PART NO.		REV.	
90-0870-02		4	
PART NAME			
UPSET PIN FOR 1.2 mm DR .3/64" BARE CABLE AUT. BIRD CAGE MACHINES			
F-MEN-071-M Rev. Jan/16/2013

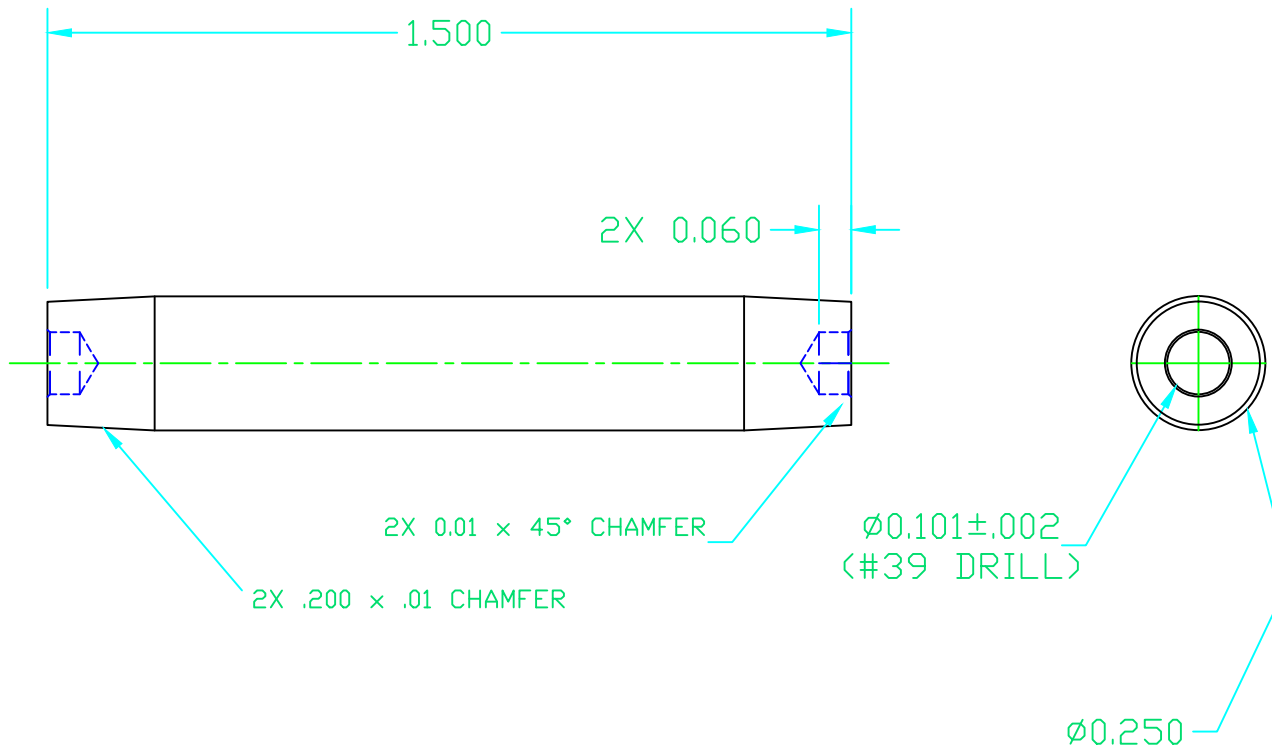
STANDARD TOLERANCES			
DECIMAL .XX = ±.010 .XXX = ±.005 ANGLES = ±2°			
MATERIAL			
D2 HT. 58/62 Rc			
FINISH			
63 OR BETTER			
BY		DATE	
WHL		06/20/91	
SCALE: 4X			
CK.	APPR.	REL.	REL. DATE
NO.	CHANGE		
1	RELEASED	WHL	6/30/92
2	REMOVED FLAT ON OD OF PIN.	ML	2/06/92
3	DIM 0.060 WAS 0.045 , 0.116 WAS 0.101, ADDED .200 X .01 CHAMFER.	DM	4/6/10
4	ø 0.101 was ø 0.116.	DM	12/04/13
